**SR-2 – STAFF ADVISORY REPORT (05-08-2026)**

**ADDRESS:** 470 MARTIN LUTHER KING JR. BOULEVARD

**APPLICATION NUMBER:** HDC2026-00162

**SCOPE:** REPLACE WOOD WINDOWS WITH ALUMINUM WINDOWS, BUILD RETAINING WALLS/INSTALL FENCING, INSTALLATION OF CMU BLOCK IN BUILDING’S EXTERIOR WALLS, (WORK STARTED WITHOUT APPROVAL)

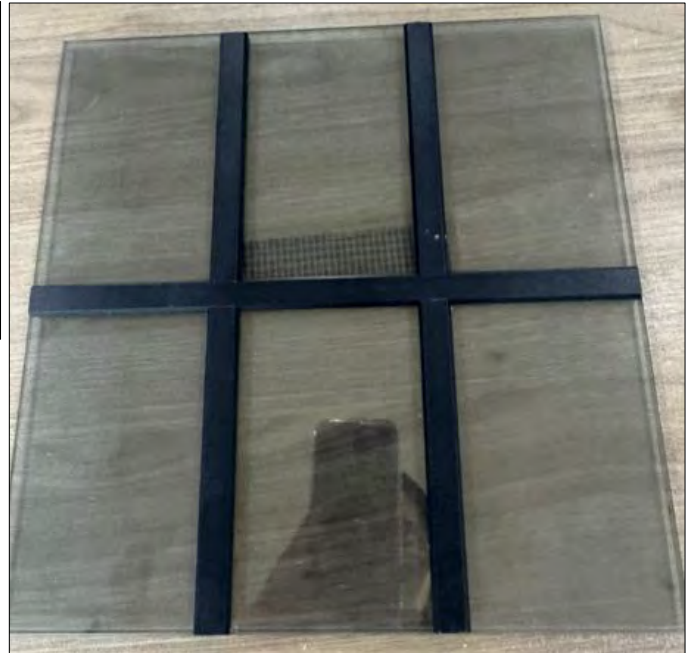
- Additionally, the applicant proposes installing flat grilles to the exterior panes of glass to match the internal grille pattern. The application does not state how the grilles will be affixed (i.e., glue?), and staff is concerned about the long-term durability, and maintenance requirements, to keep these grilles in place after continued exposure to the elements. Photo comparison of proposed grilles and historic muntins are on the following page.

- Even though this product may be applied to the exterior, it appears to extend from the glass surface about 1/8-of-an-inch and is flat surfaced.
- Pages 11 & 12 from applicant document "Compiled Submittal red" states depths for the grilles at .15" and .45" for different windows. Staff isn't clear why different dimensions are listed; the above sample is likely for the .15" grille.

- The full glass photo also shows a tint which reduces transparency and contrast between the grilles and glass. Staff isn't clear if this glass matches the glass used within the new windows.

- There is one window remaining at the façade that offers clarity on the profile/ dimensionality of a historic muntin and is likely identical to what was in place within the façade's historic-age double-hung windows. The angled surface and almost pointed outer edge of the historic muntins offers an entirely different expression than the almost flat proposed grilles.

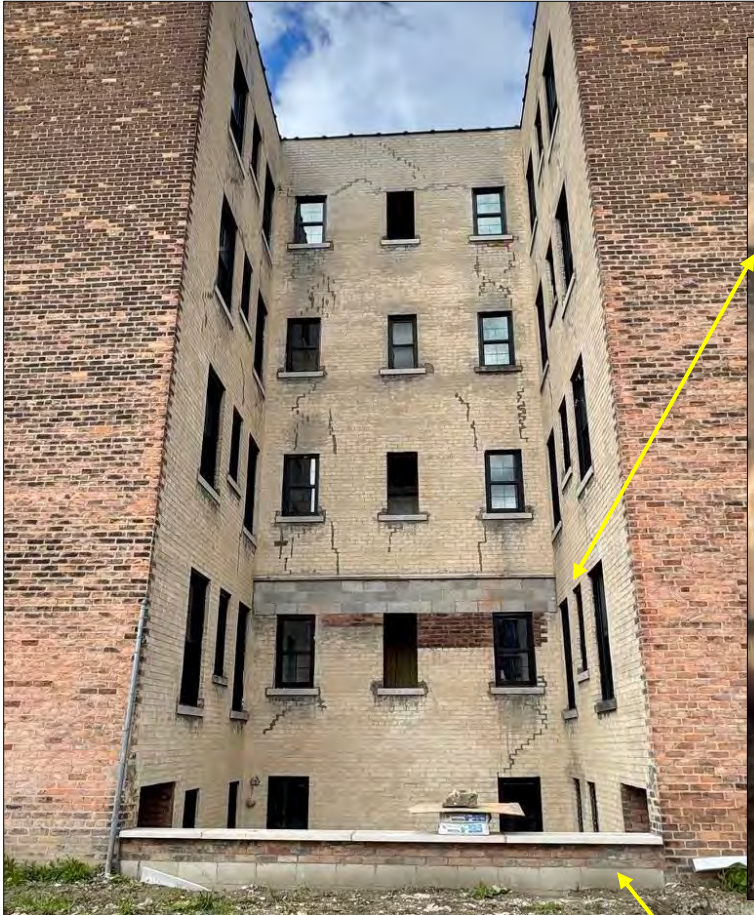
- Using the east wall’s central courtyard/lightwell as an example of work that has been completed in the remaining lightwells: replacement windows fill most of the openings, a portion of an exterior wall was rebuilt using CMU, and a CMU and brick retaining walls topped with cast stone were erected.

- The discolored brick condition of the interior wall was consistent at each identical wall location; however, close photos of this brick surface were not submitted to allow the Commission to assess the condition and reason for the discoloration. The applicant states this area of brick was “surface coated in mortar and not salvageable”. Additional full wall photos

- The historic brickwork pattern used to construct this *apparent* load-bearing wall, common (i.e., American) bond with 6 courses of stretchers divided by a single course of headers, was not reproduced or preserved by the CMU infill. The distinctive and historic brickwork pattern was a character-defining feature.

- The applicant states CMU block was used "for durability"; however, new brick (matching all details of the historic brick, including color) is the correct historic preservation treatment, including the area where red reclaimed brick was used. New brick is generally harder and has a higher compressive strength than early 20<sup>th</sup> century brick due to the use of higher kiln temperatures. Therefore, the new bricks would be denser and less porous than the previous bricks. Using lime mortar (matching the historic mortar) would absorb the surface water more quickly, possibly requiring tuckpointing or repointing more regularly, but new yellow brick would retain a consistent wall cladding and blend into the historic building design, while retaining the historic character of the element.

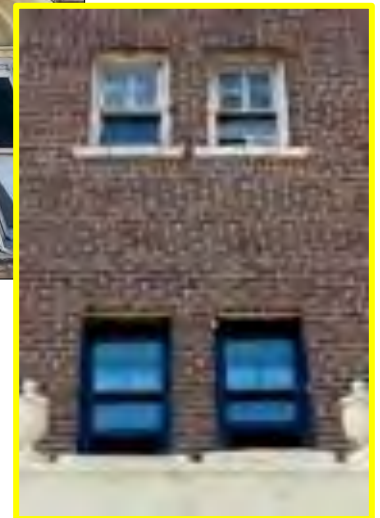
- The replacement of the building’s windows was noticed in early April and continued later in the month after BSEED had issued a stop work order. Now, only a few original wood windows remain.
- It is staff’s opinion that the windows did not appear to be deteriorated beyond repair. The undivided glass on the façade removed without HDC approval between time of district designation and May 2026 could have been replaced with fabricated true-divided light sash.

- Although the expansion of a portion of the above photo is a bit blurry, the difference between the historic and new windows remains quite evident. The dimensionality of the historic divided-lights has been lost and the flatness of the new window frames and loss of dimensional brickmold creates a heavy, thick appearance to the new windows. **Even with an applied exterior grille it is wide and flat, unlike the dimensional quality of the historic muntin, and the** contrast between the dark brick and black window frames causes the window openings to look like dark holes in the wall, rather than an integral component of the wall.

*Full west side of building. Staff photo, 04/30/2026.*

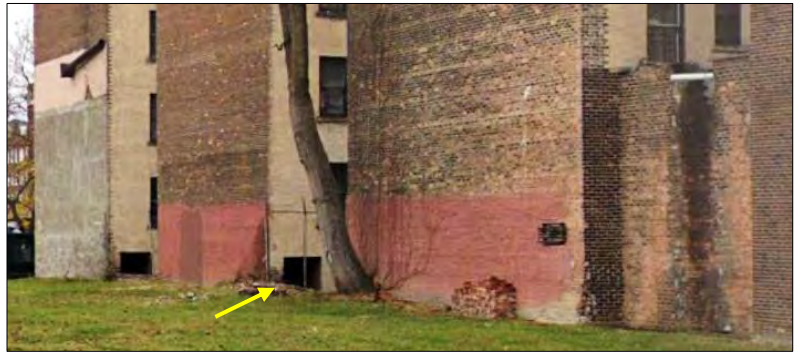
- Regarding the CMU blocks used for many of the retaining walls, the applicant stated they will be raising the grade around the building and the CMU will not be visible.
- However, staff's analysis of the five completed retaining walls shows the east and west retaining walls were constructed differently from each other: the three walls at the west side lightwells are composed of 4-6 courses of brick, whereas the east side lightwells have three courses of brick and CMU block. Therefore, staff is concerned that one or more rows of CMU may be visible on the east side when the grade for the lot is leveled.

- In the close-up photos of the five retaining walls (evident by the remaining weeds in the mostly undisturbed surrounding ground visible in the photo on page 12 and the middle photo on this page), the current ground surface appears to be below the top three courses of brick.

- The use of CMU block on these walls, however, is not compatible material for use at a historic location spanning the walls of an early 20<sup>th</sup> century building.

Above: Staff photos of façade and west and east existing exterior entrance doors

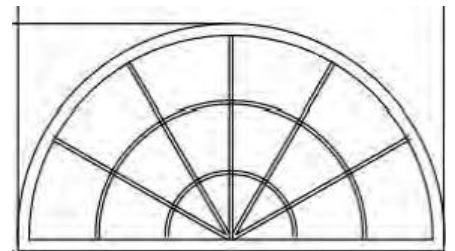
- The applicant proposes, as part of the window replacement, to install half-round, between-the-glass grid, aluminum windows in the arched openings (5) that span the façade’s first floor. The aluminum doors (likely installed ca. 1950-1970) will be replaced with an ornate double door (material not noted in applicant documents) with a black finish.

- The adjacent drawings were copied from the applicant’s document “*Compiled Submittal Red*”.
- It is staff’s opinion the ornately designed doors are not appropriate for the Colonial Revival style building as the doors would impart a level of detail not found on the building. The arched windows above each door/window opening at the first floor is a historic component and should not be mimicked in any other opening. The highly decorative, dimensional doors would become focal points, rather than compatible elements deferring to the authentic historic character of the building.
